Stormwater Detention and Infiltration Design Data Sheet

Stormwater Facility Name: **Clear View Industrial Park, Filing 2A** ← 2B

Facility Location & Jurisdiction: **El Paso County**

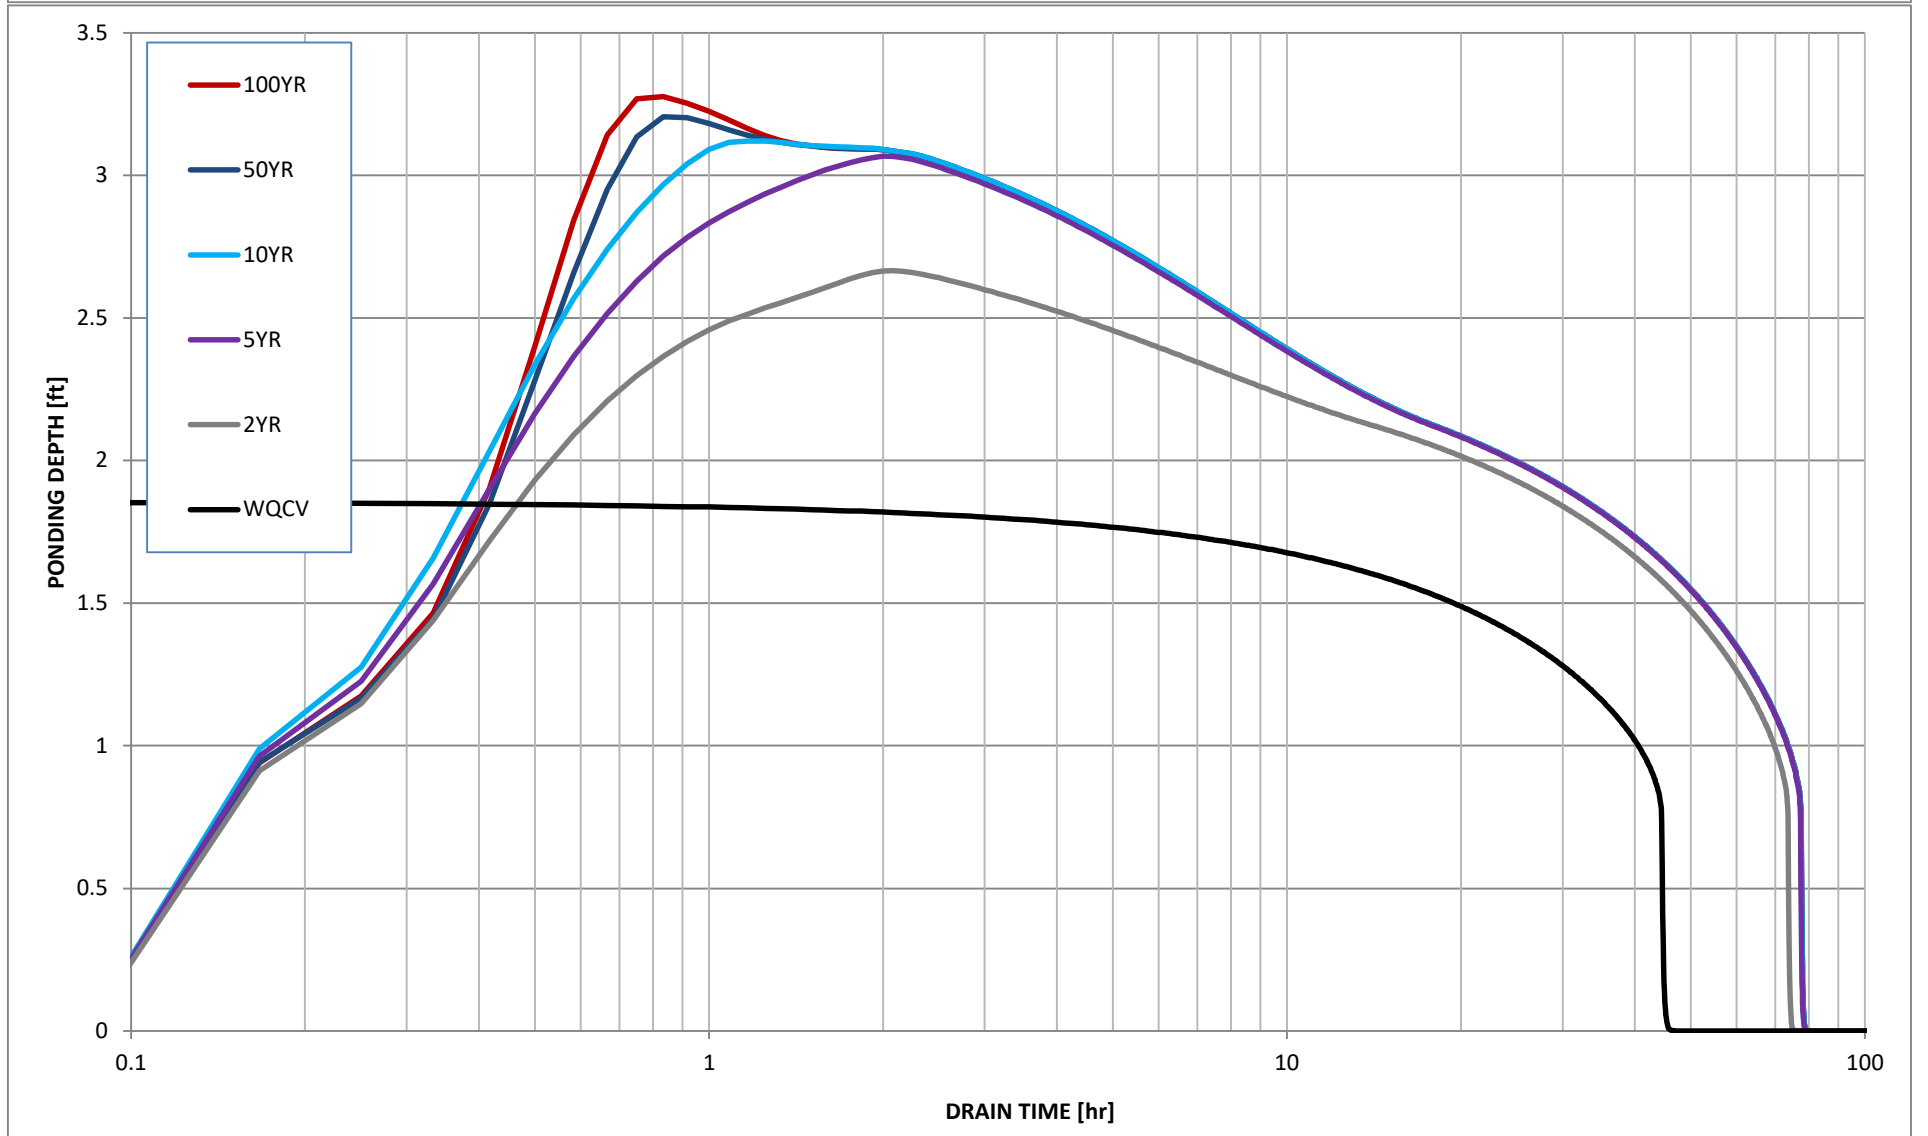
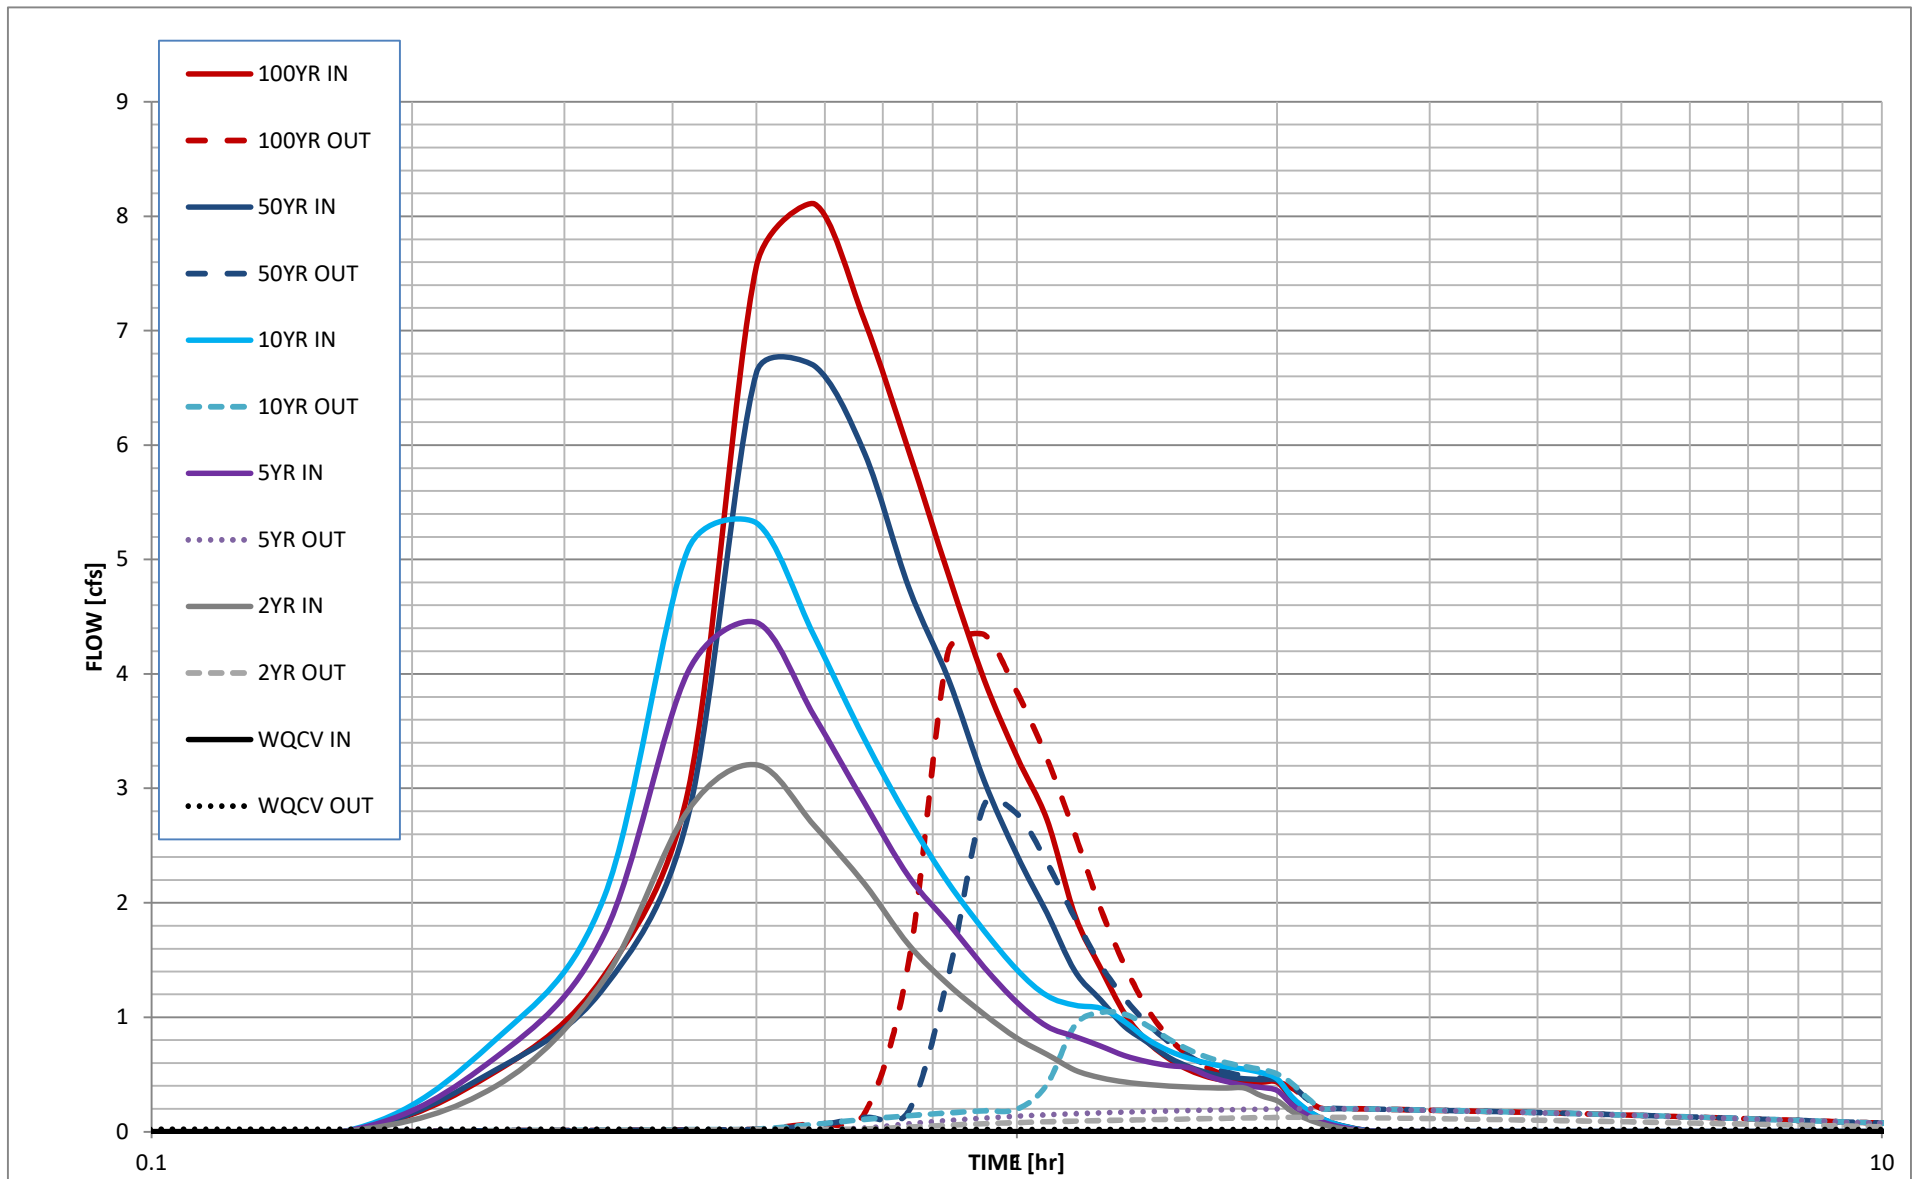
Double check these User Defined Discharges because the Time to Drain numbers are way different than on the UD-Detention Worksheet in the FDR. Revise discharges on this SDI form so that drain times are closer to UD-Detention ones.
